Pentium[®] Processor for Embedded Applications

Specification Update

January 1999

Order Number: 273183-003

68. Asserting TRST# Pin or Issuing JTAG Instructions Does not Exit TAP Hi-Z State

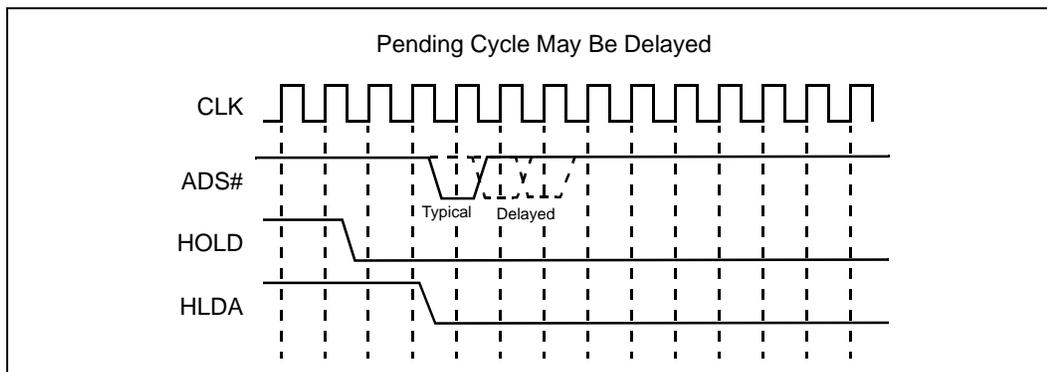
Problem: The *Pentium® Processor Family Developer's Manual*, Section 11.3.2.1 states that the TAP Hi-Z state can be terminated by resetting the TAP with the TRST# pin, by issuing another TAP instruction, or by entering the Test_Logic_Reset state. However, the indication that the processor has entered the TAP Hi-Z state is maintained until the next RESET. Therefore by using the above methods alone, the TAP Hi-Z state can not be terminated.

Implication: When the TAP Hi-Z instruction is enabled and executed, the processor may not terminate the Hi-Z state.

Workaround: To exit TAP Hi-Z state, in addition to the methods described above, the processor needs to be RESET as well.

69. ADS# May be Delayed After HLDA Deassertion

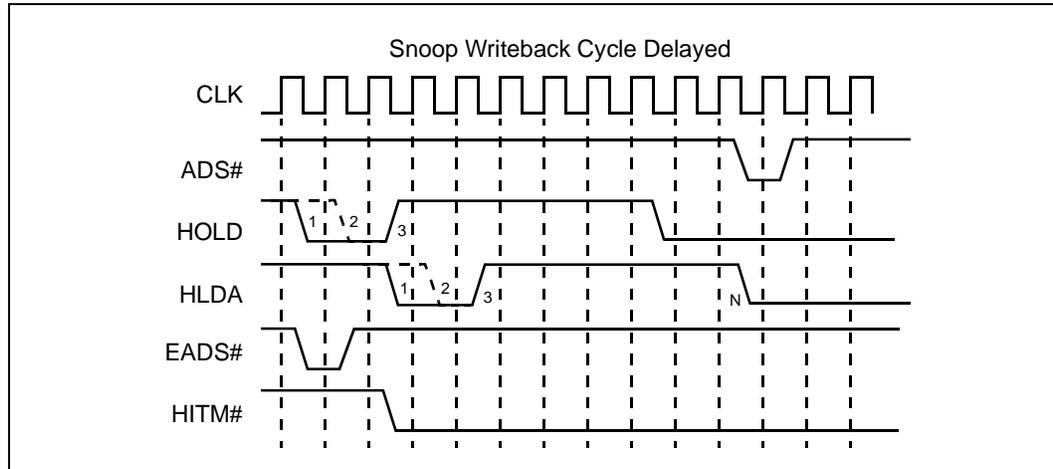
Problem: The Pentium processor typically starts a pending bus cycle on the same clock that HLDA is deasserted and the Pentium processor with MMX technology typically starts the cycle one clock after HLDA is deasserted. However, in both processors it may be delayed by as many as two clocks. See the diagram below:

In two cases, for example, if HOLD is deasserted for one clock (i.e., clock 2) or two clocks (i.e., clocks 1 & 2) and then reasserted, the window may not be large enough to start a pending snoop writeback cycle. The writeback cycle may be delayed until the HLDA is deasserted again (i.e., clock N). See diagram below.

Implication: If the system expects a cycle, for example a writeback cycle, and depends on this cycle to commence within the HLDA deassertion window, then the system may not complete the handshake and cause a hang.

1. Deassert HOLD for at least 3 clocks (i.e., clocks 1, 2, and 3 shown in figure) before reasserting HOLD again. This ensures that the Pentium processor initiates any pending cycles before reasserting HLDA.
2. If the system is waiting for the snoop writeback cycle to commence, for instance if HITM# is asserted, the system should wait for the ADS# before reasserting HOLD.
